CALL NO. 304
CONTRACT ID NO. 171048
ADDENDUM # 1

Subject: Hopkins County, FD04 SPP 054 041A 000-002
Letting December 8, 2017

- (1) Revised - Note -Page 22 of 201
- (2) Revised - Special Note -Page 27 of 201
- (3) Revised - Bid Items -Pages 197-201 of 201
- (4) Added - Sheets -Pages 1-93 of 93
- (5) Revised - Plans -Pages R2j, R2k, T9, T16A, T17A, T17, U92 and U93

FILE NAME: G:\PWORK\ADAM.PROCTOR\1378208\22-CAMERA NOTES (SP1).DGN
 USER: adam.proctor
 DATE PLOTTED: December 1, 2017
 E-SHEET NAME: T016A0SP
 MicroStation v8.11.9.832

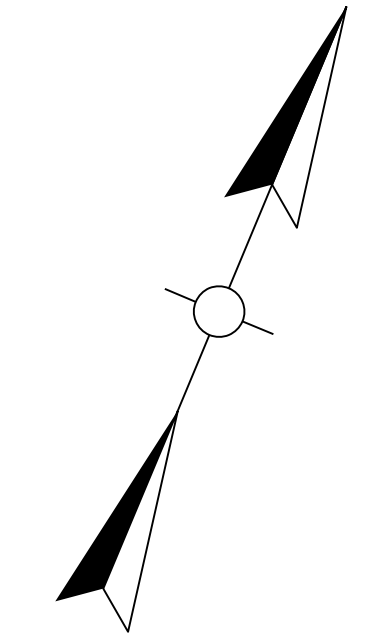
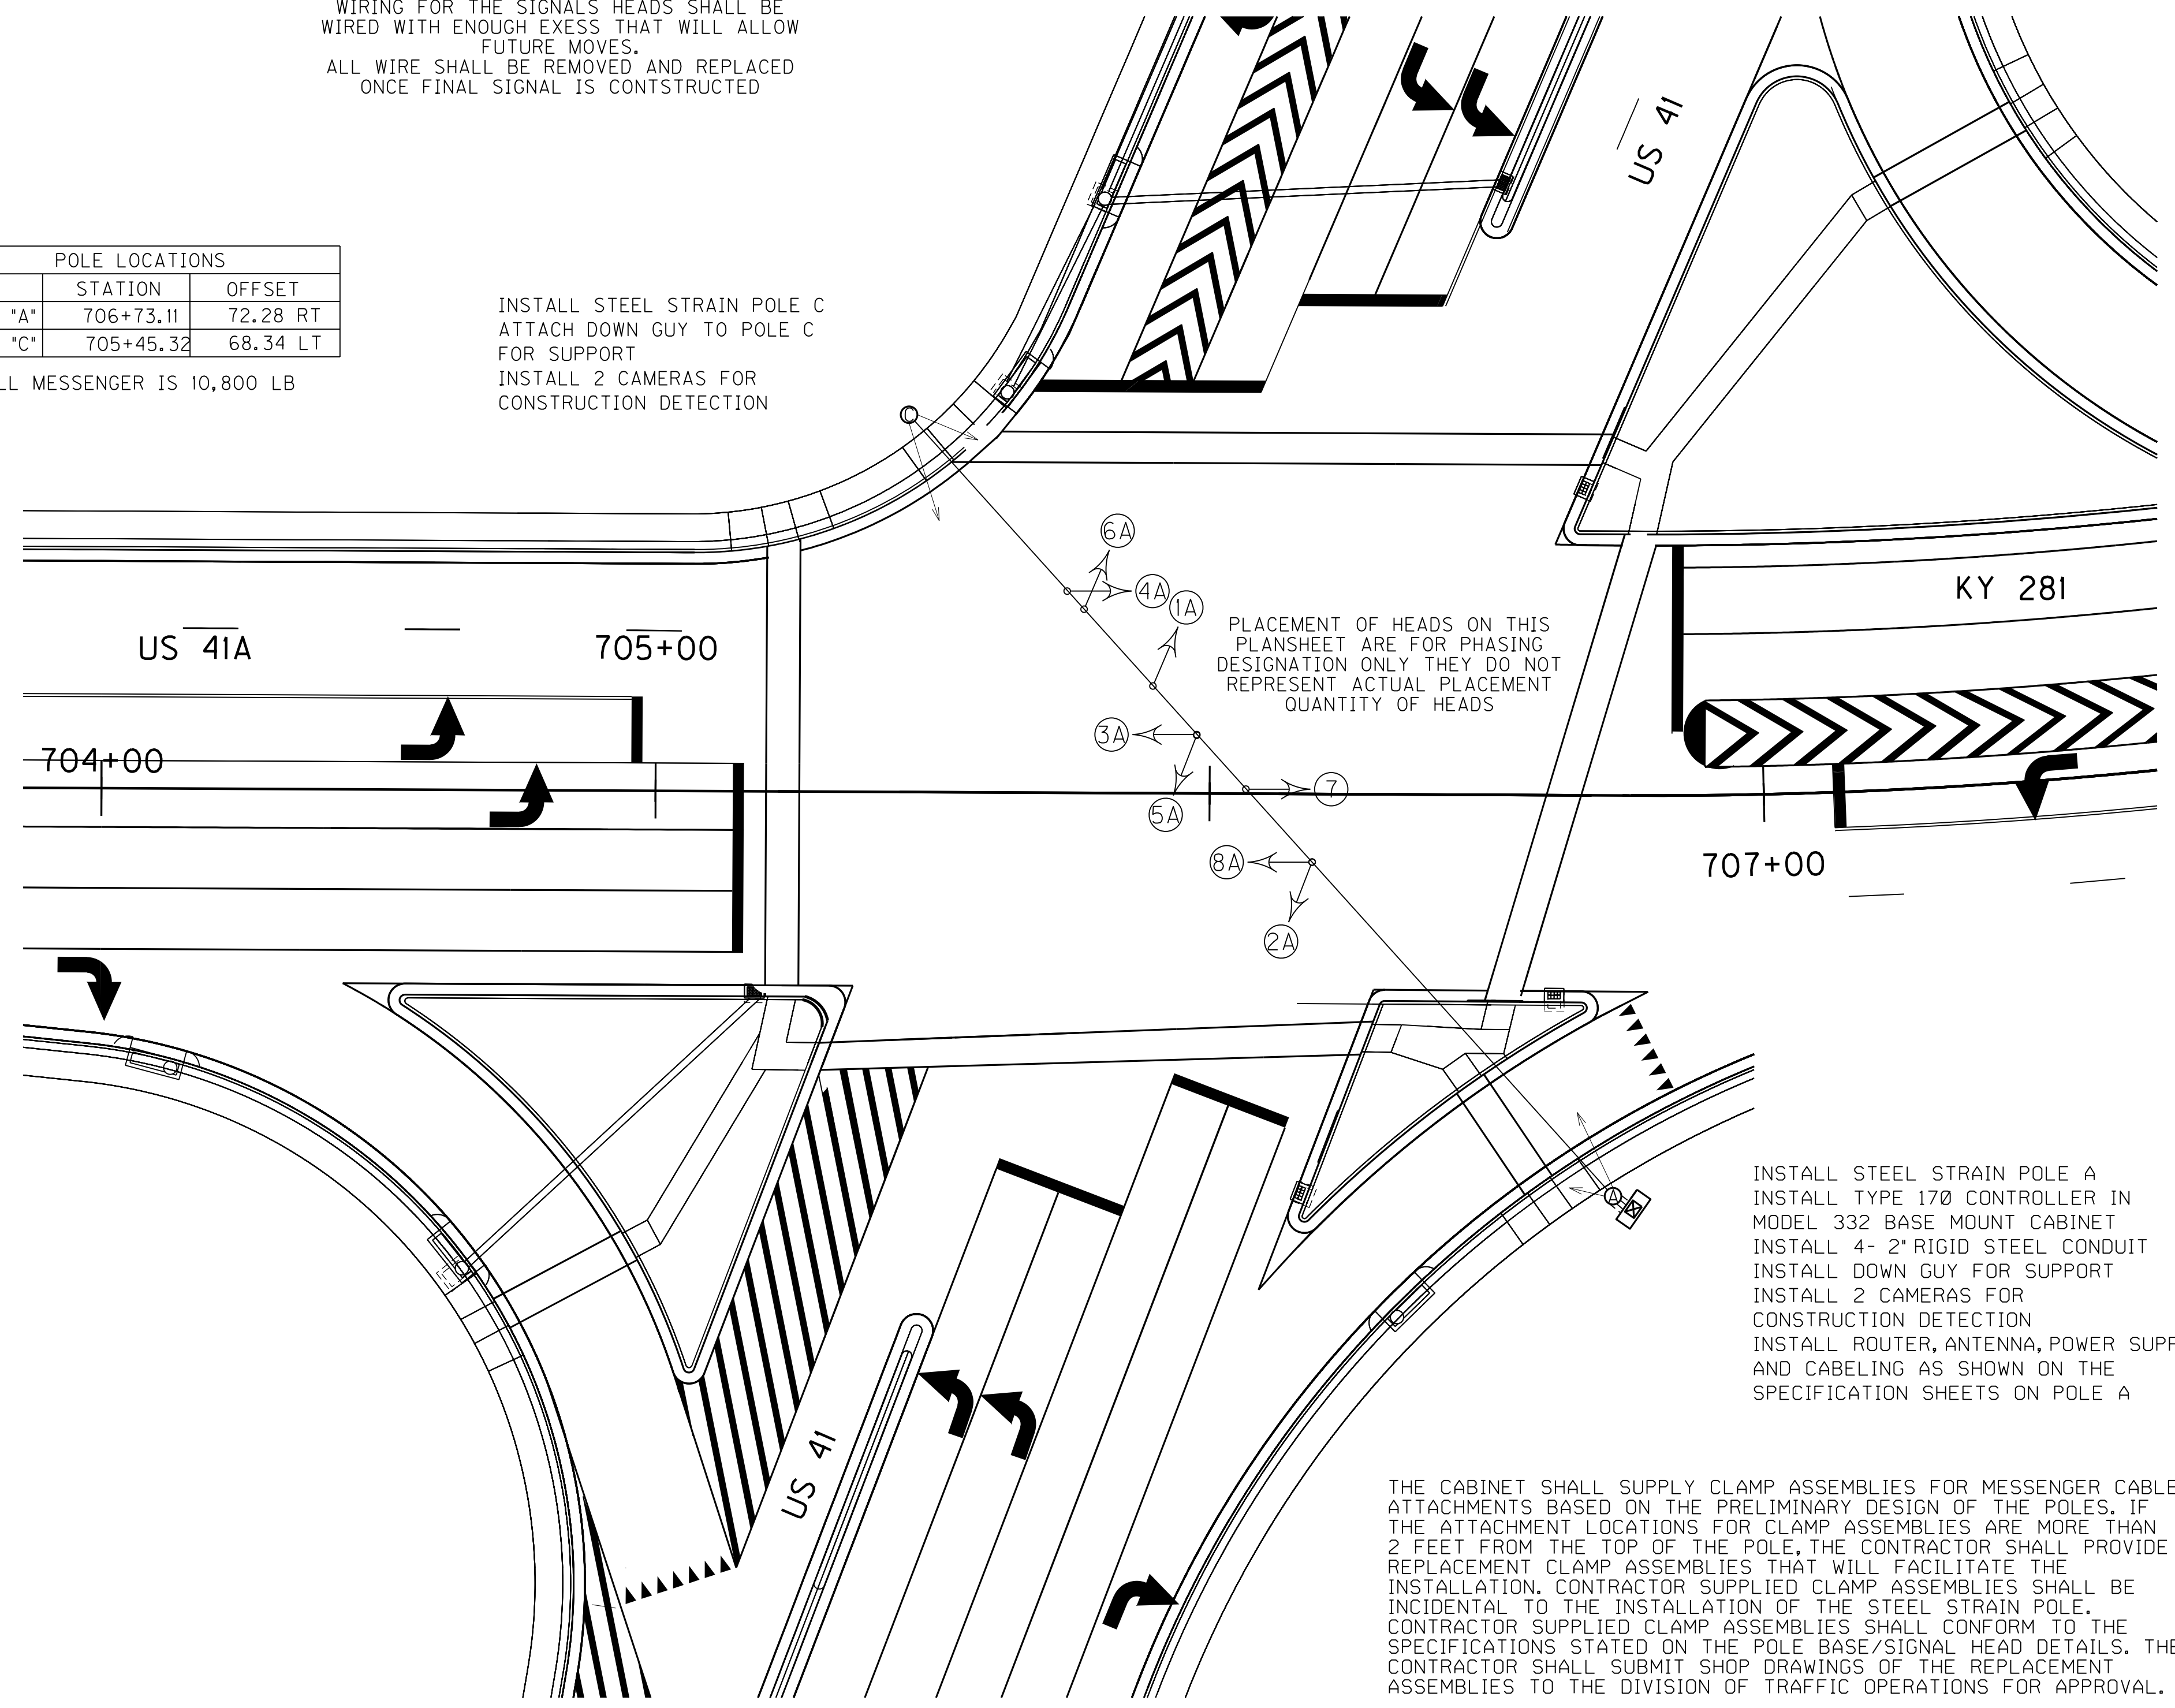
REVISED 11-30-2017

INSTALL STEEL STRAIN POLE C
 ATTACH DOWN GUY TO POLE C FOR SUPPORT
 INSTALL 2 CAMERAS FOR CONSTRUCTION DETECTION

FILE NAME: C:\P\WORK\ADAM\PROJECTS\RD1378208\DIAGONAL TEMPORARY.DGN
 USER: adam.proctor
 DATE PLOTTED: December 1, 2017
 E-SHEET NAME: T017A05G
 MicroStation v8.11.9.832

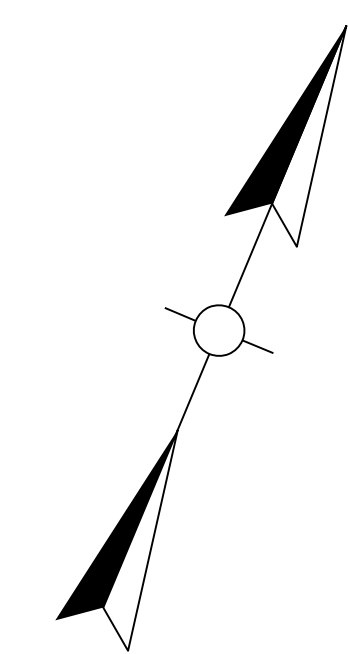
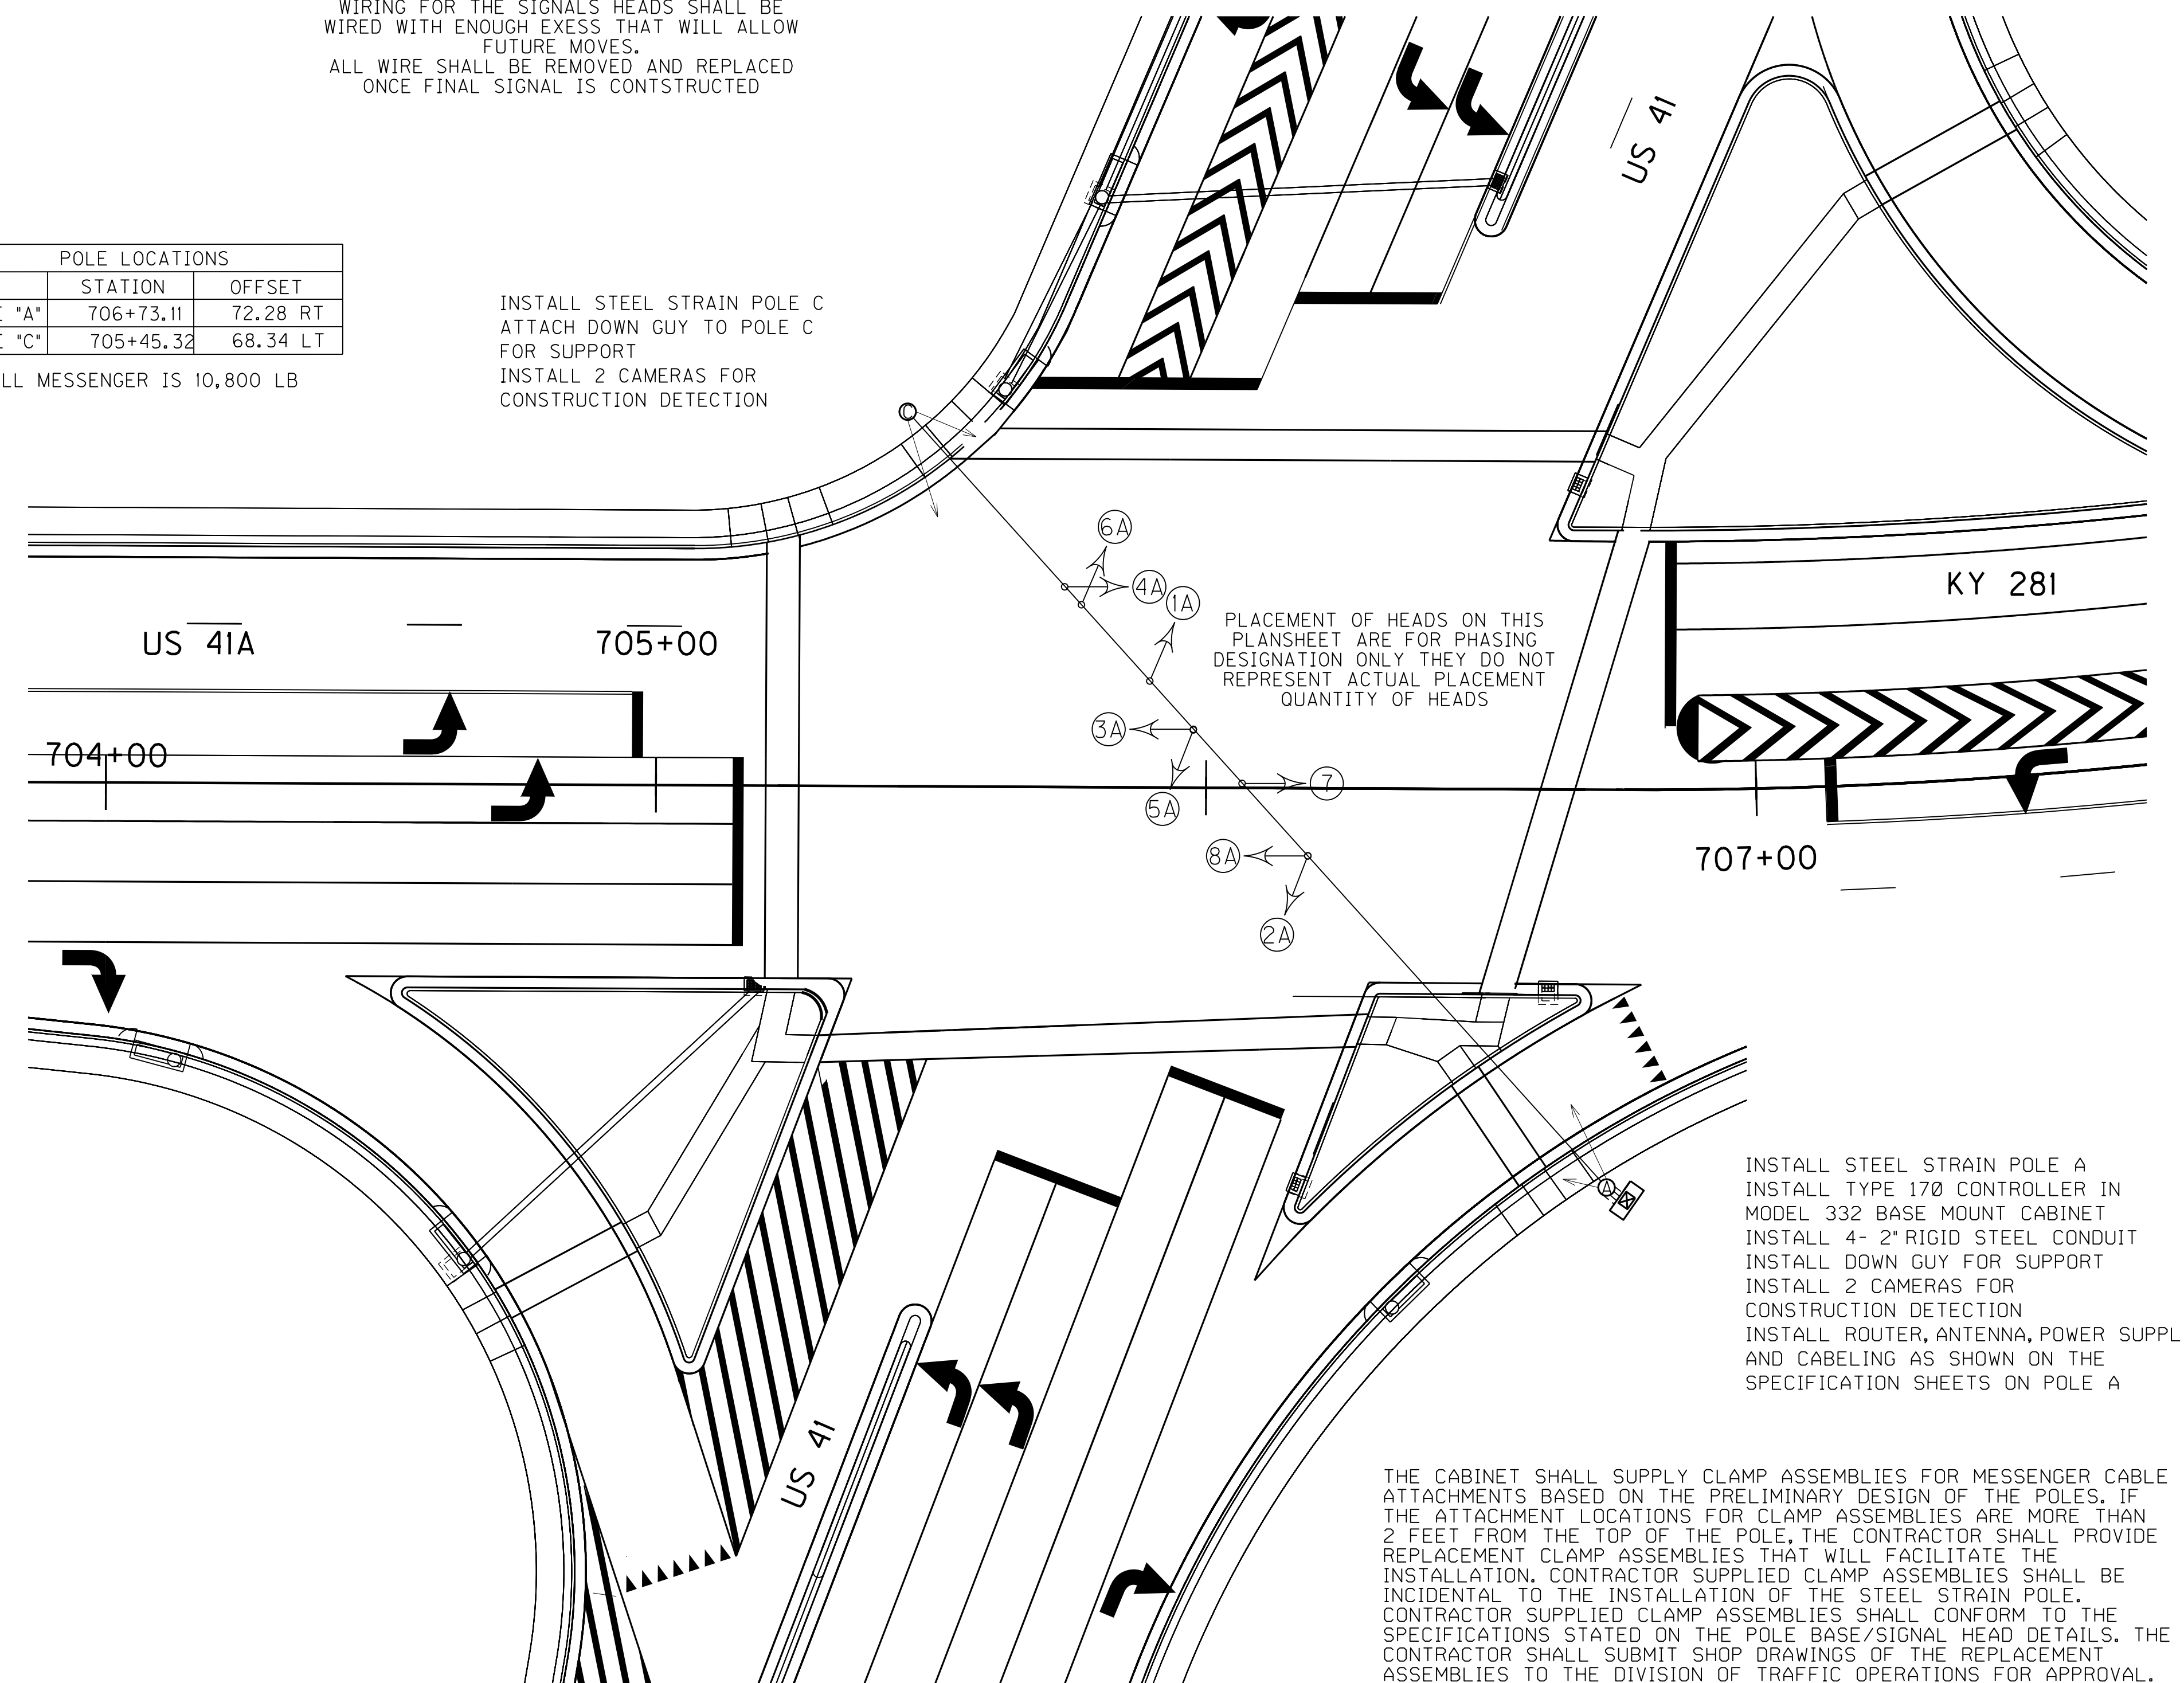
REVISED 11-30-2017

INSTALL STEEL STRAIN POLE C
 ATTACH DOWN GUY TO POLE C FOR SUPPORT
 INSTALL 2 CAMERAS FOR CONSTRUCTION DETECTION
